# PARTS & SERVICE

REF NO. AT97109 DATE Jun. 6, 1997 Page 1 of 6

IMPROVEMENT HYD. OIL COOLER PIPING ON WA800/WA900-1

**PURPOSE:**

#### 1. Introduction

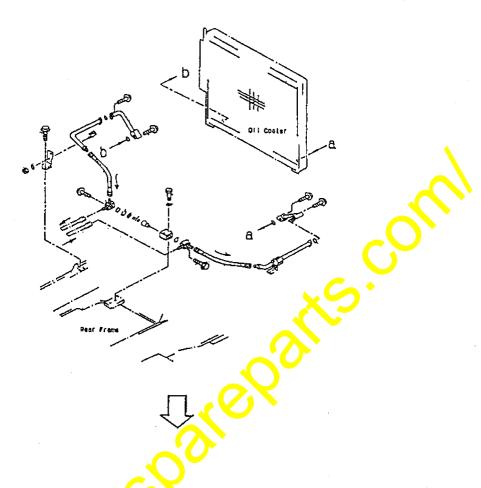
With the WA800 and WA900 wheel loaders, the peak internal pressure contring in the hydraulic circuit connecting to the inlet of the hydraulic oil cooler may cause cracks in the header root section of the piping for the air-cooling type hydraulic oil coolic, leading finally to an oil leakage To prevent occurrence of such a failure, execute the codification introduced in this Service News.

### 3. Contents of the modification

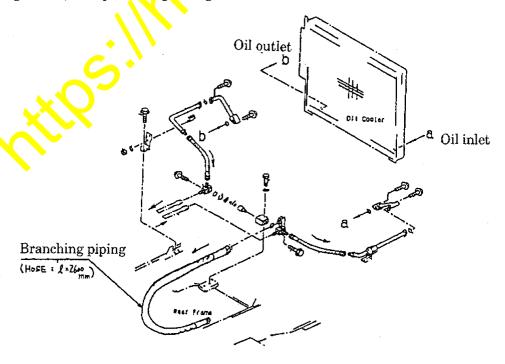
• Supplement a branching piping to the indication draulic circuit connecting to the inlet port of the hydraulic oil cooler to absorb peak internal pressure occurring in this section when steering is changed over, thus preventing damage to the oil cooler.

### (2) Reworking

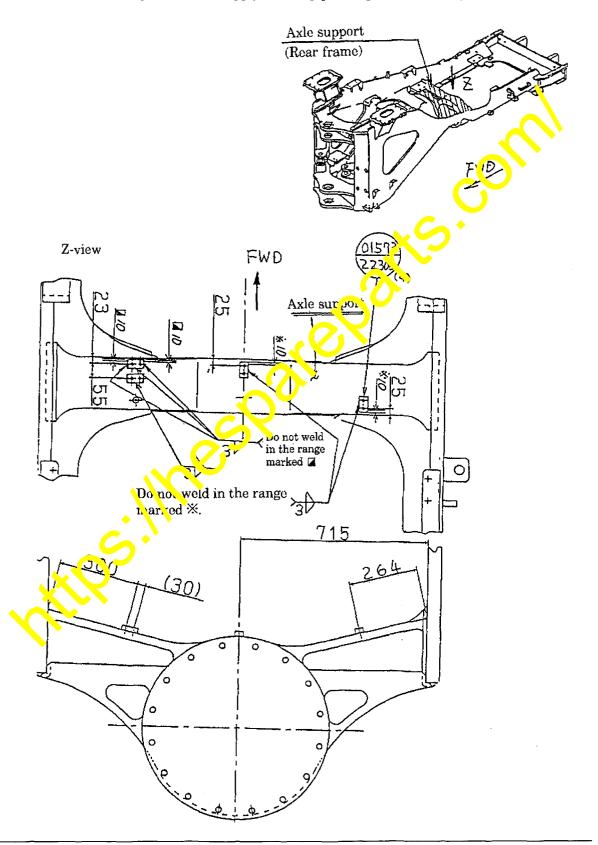
Weld four seats (01573-22306) at the designated positions on the upper surface of the axle support namely, the hatched section in the schematic diagram below.

(Note) After finishing this rework, apply touch-up painting over the weld joints.
